Access Compliance Report

Public Rights-of-Way

(Curb Ramps)

Intersection ID: 5654	Main Street: JOHN_KIRK_DR	Cross Street: VAN_LANDINGHAM_RD	Location: SW
ADA ID: 0FB21B16EAA3	Ramp Type: Perp	Initial Pass/Fail: Fail	Overall Compliance: No
Severity Score: 22.5			
Codes/Mitigation Info/Possible Solution		Field Measurements/Component Compliance

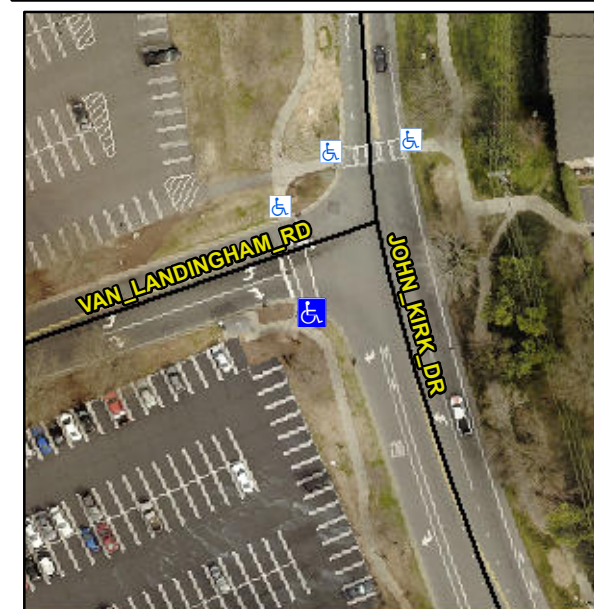
Not Found, R304.5.1, R304.2.2, R304.5.3

Compliance	Description	Data	Compliance	Description	Data
N/A	Ramp Length (in)	91.0	No	Ramp Slope (%)	11.4
No	Ramp Width (in)	46.0	No	Ramp XSlope (%)	4.5
N/A	Flare Type LT	N/A	N/A	Flare Type RT	N/A
N/A	Flare Slope LT (%)	N/A	N/A	Flare Slope RT (%)	N/A
N/A	Flare Traversable LT?	N/A	N/A	Flare Traversable RT?	N/A
N/A	Landing Length (in)	N/A	N/A	DWS Provided?	N/A
N/A	Landing Width (in)	N/A	N/A	DWS Contrast?	N/A
N/A	Landing Slope (%)	N/A	N/A	DWS Length (in)	N/A
N/A	Landing X Slope (%)	N/A	N/A	DWS Full Width?	N/A
N/A	Landing Curb? (Y/N)	N/A	N/A	DWS Offset (in)	N/A
N/A	Shared Landing?	N/A			
N/A	Gutter Ponding?	N/A	N/A	Gutter Slope (%)	N/A
N/A	Gutter Lip Ht (in)	N/A	N/A	Gutter X Slope (%)	N/A
N/A	Painted X Walk1?	Yes	N/A	Painted X Walk2?	N/A
	X Walk 1 Direction	To N		X Walk 2 Direction	N/A
N/A	X Walk 1 Width (in)	83.0	N/A	X Walk 2 Width (in)	N/A
	X Walk 1 Slope (%)	6.9		X Walk 2 Slope (%)	N/A
	X Walk 1 X Slope (%)	2.9		X Walk 2 X Slope (%)	N/A

Remove & Replace Entire Ramp.
